OXNARD SCHOOL DISTRICT

AGENDA
REGULAR BOARD MEETING
Wednesday, August 21, 2019

FIRST FLOOR - CLASSROOM BUILDING - MECHANICAL PLAN
1/8" = 1'-0"

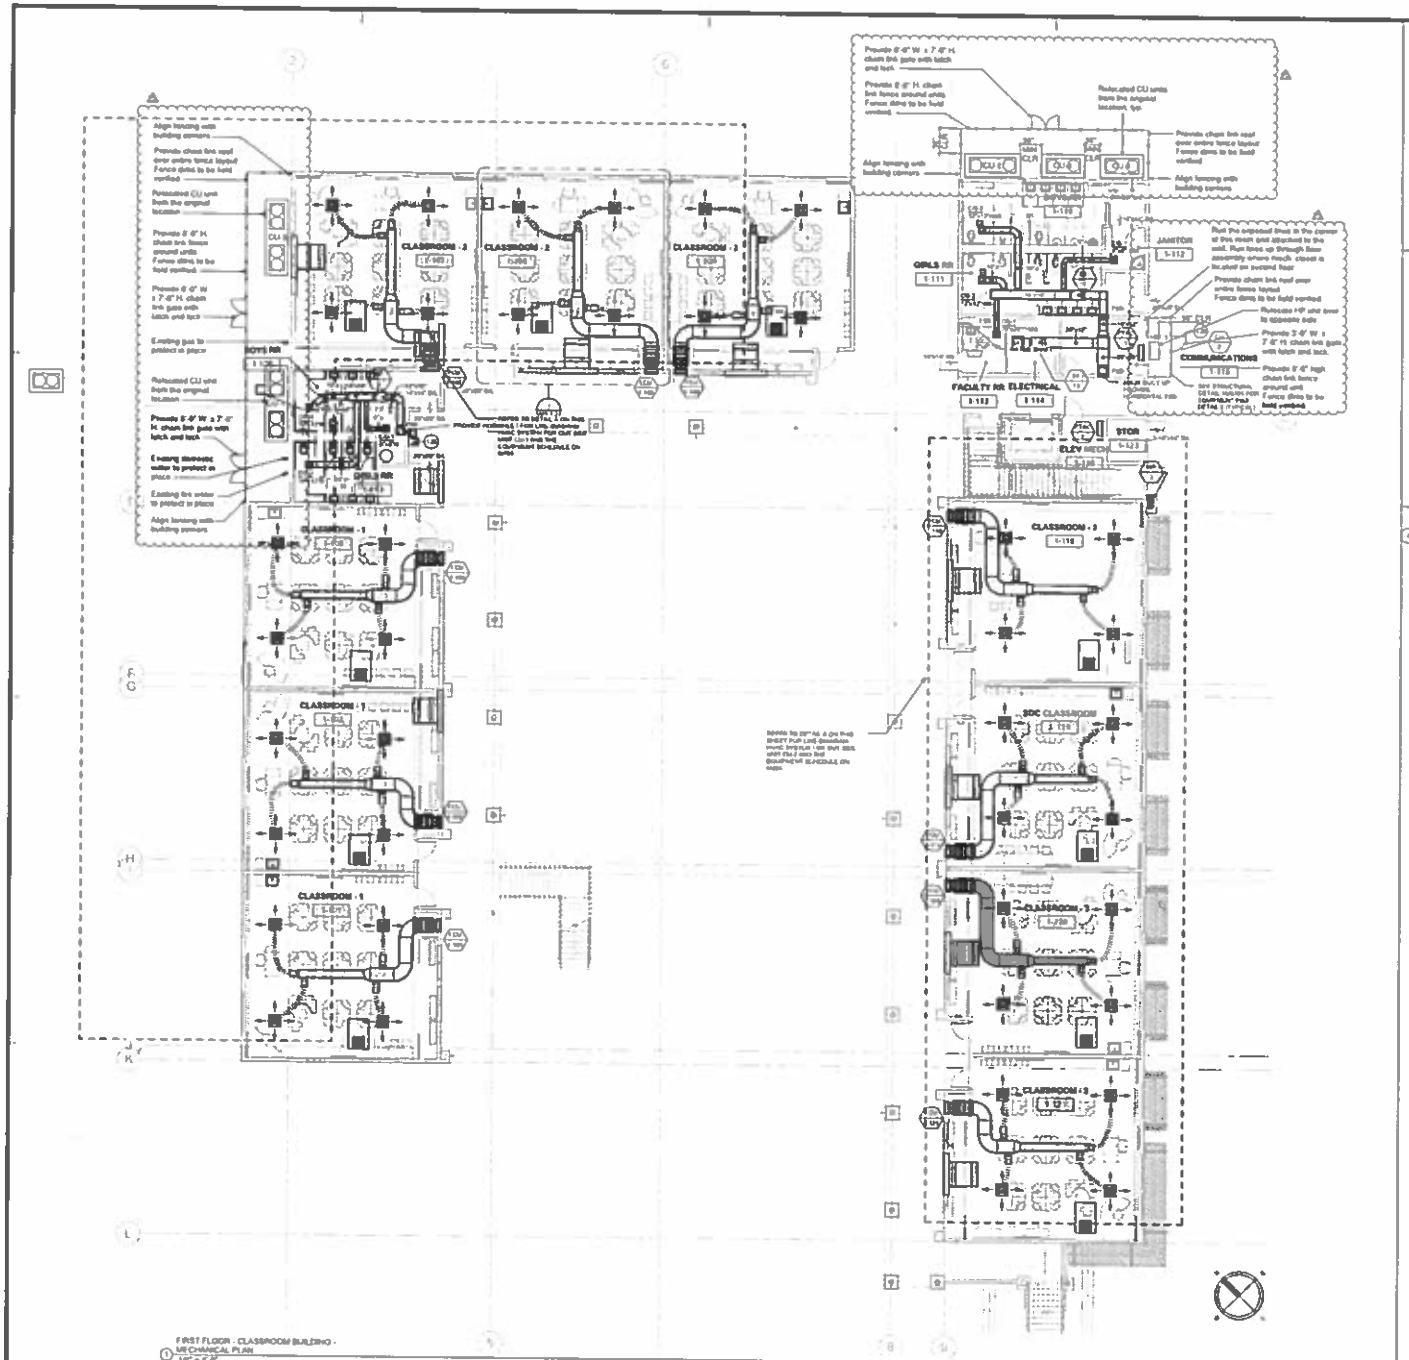
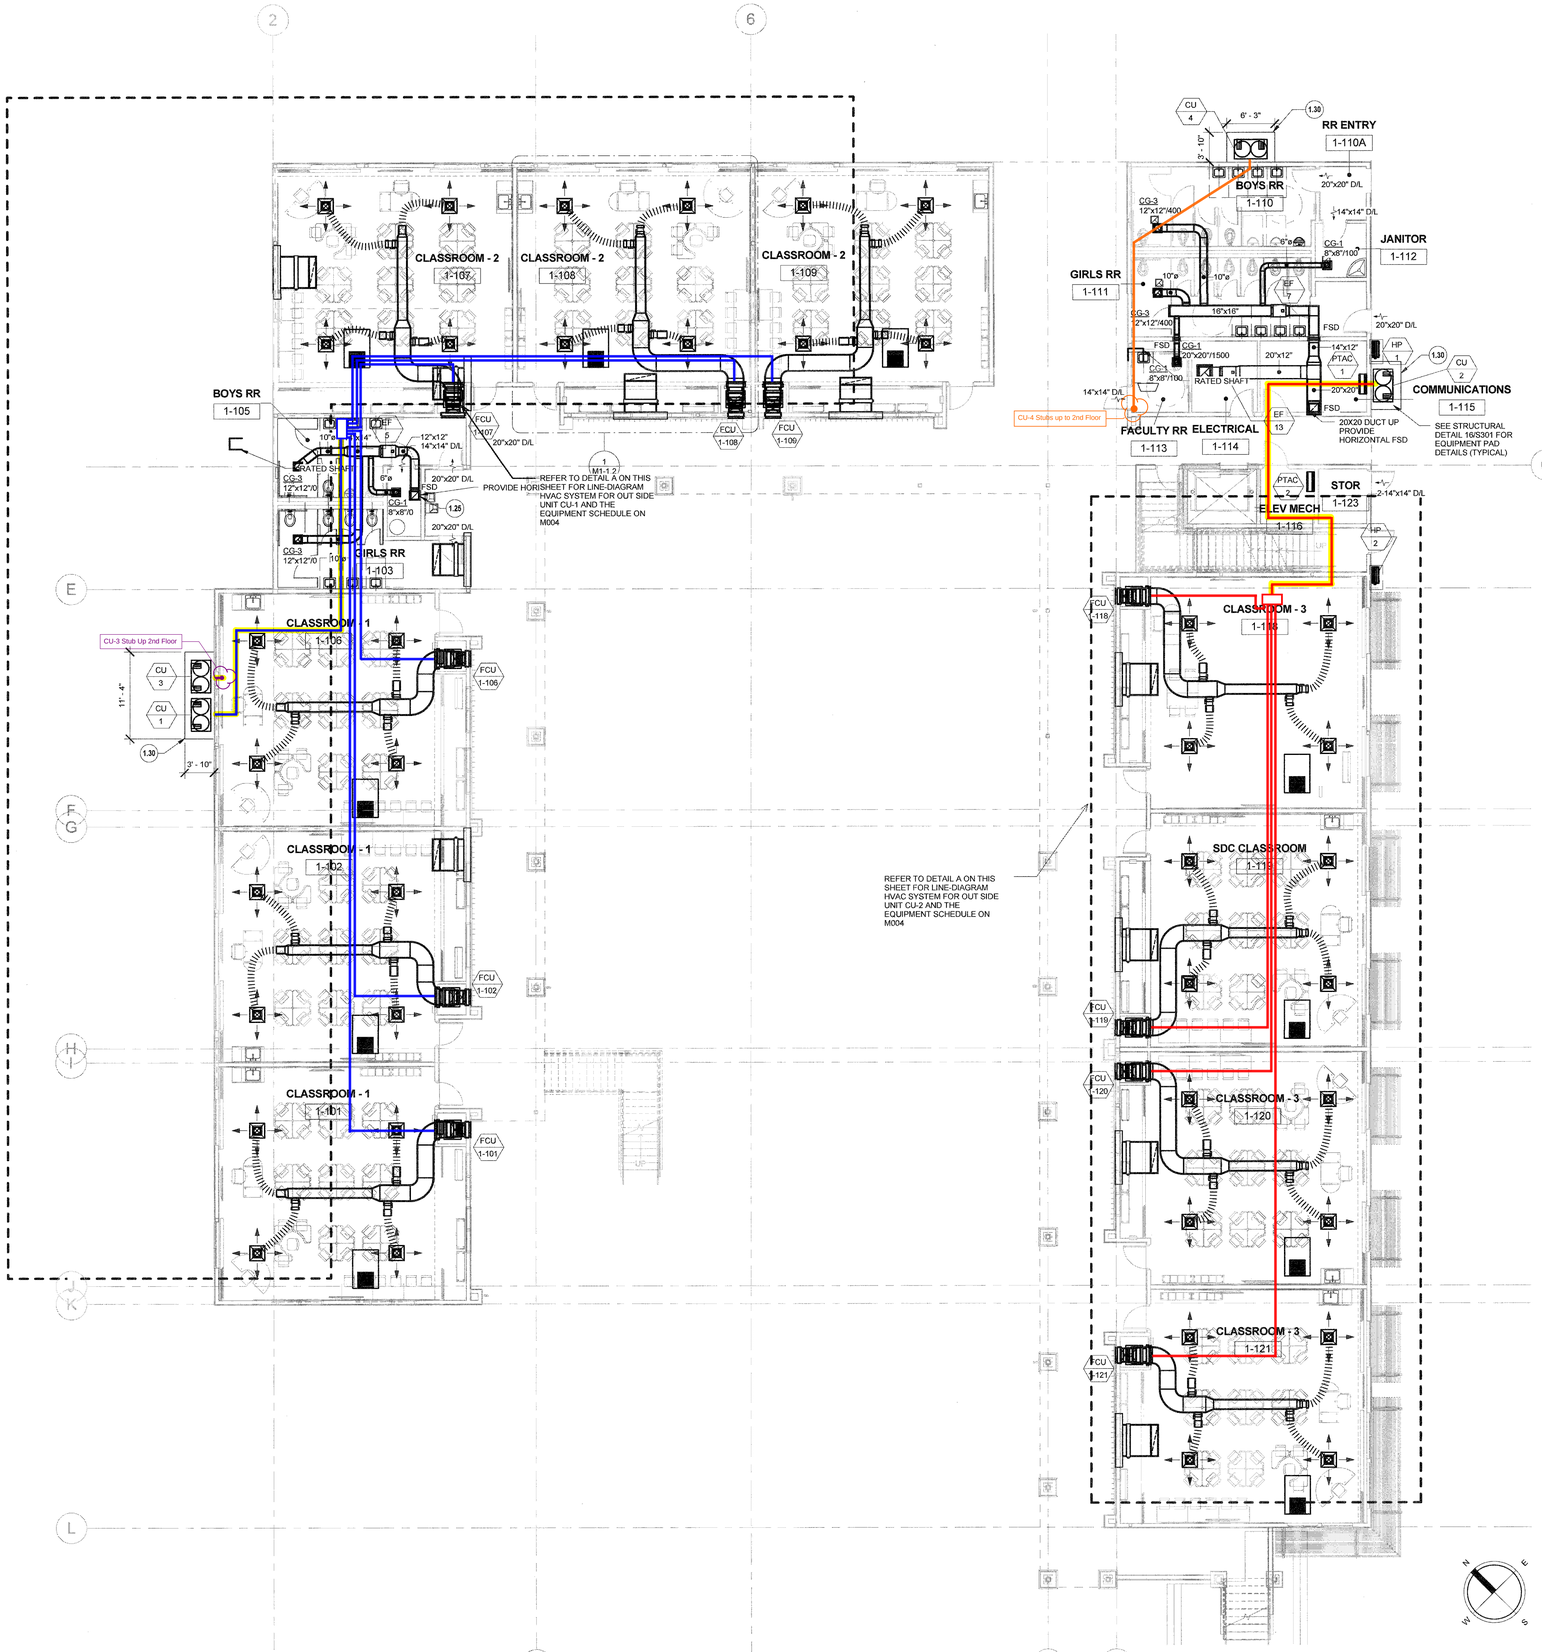
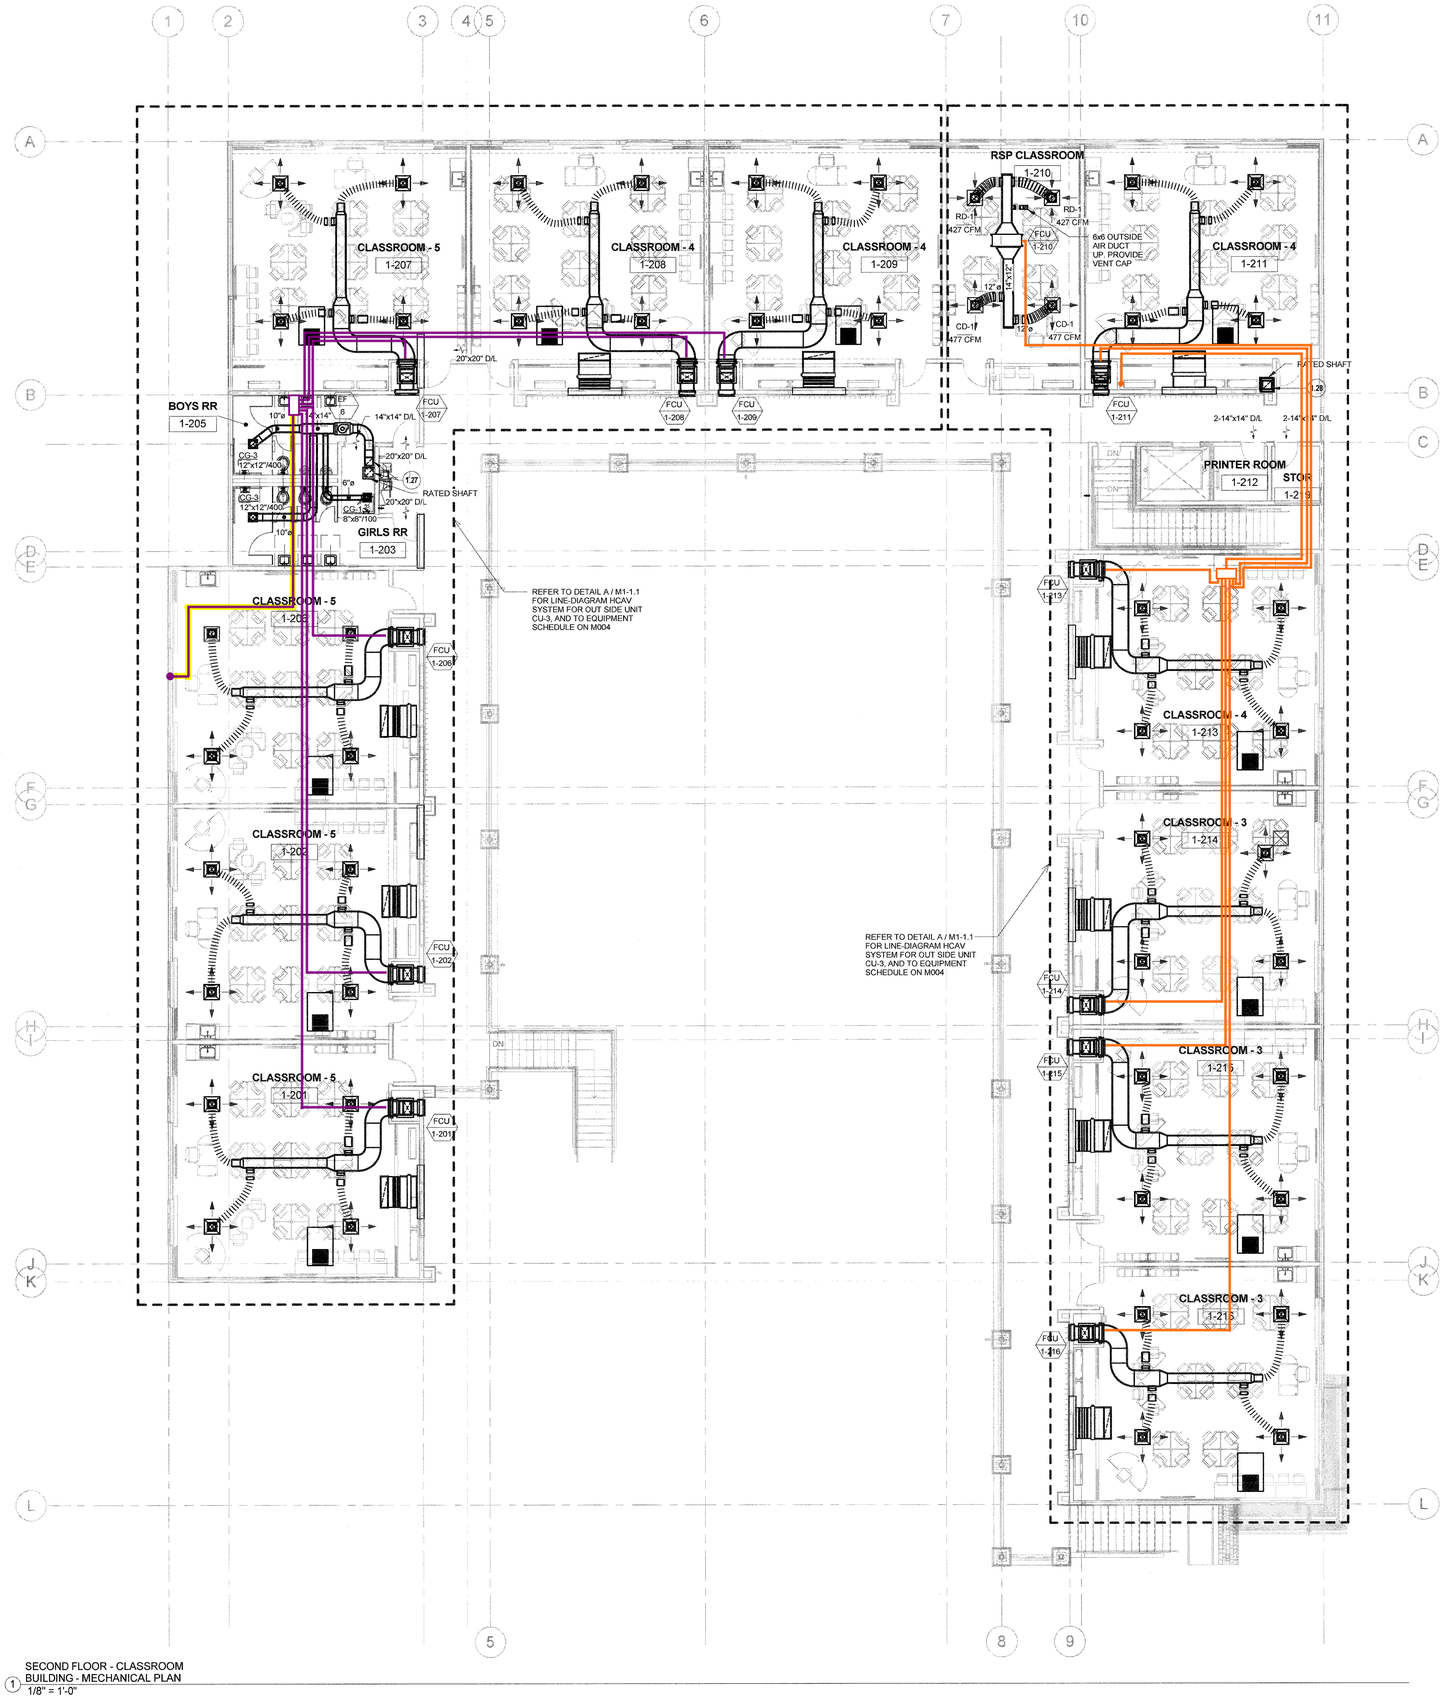
Changes to Drawings and/or Specifications:
Revisions to Architecture sheets:
A1-11.1: Room 1-115, run exposed lines in corner of room and attach to the wall.
A1-11.2: Added chase to classroom 1-206. For room 1-211, run all line sets from communication room (1-115) below into mechanical closet on second floor. (1-211)
A-61.2: Wall types for reference.
M1-1.1: Revised locations of the condensate units and heat pump to be closer to the interior chase walls.
M1-2.0: Shown location of routed lines in mechanical closet in room 1-211.
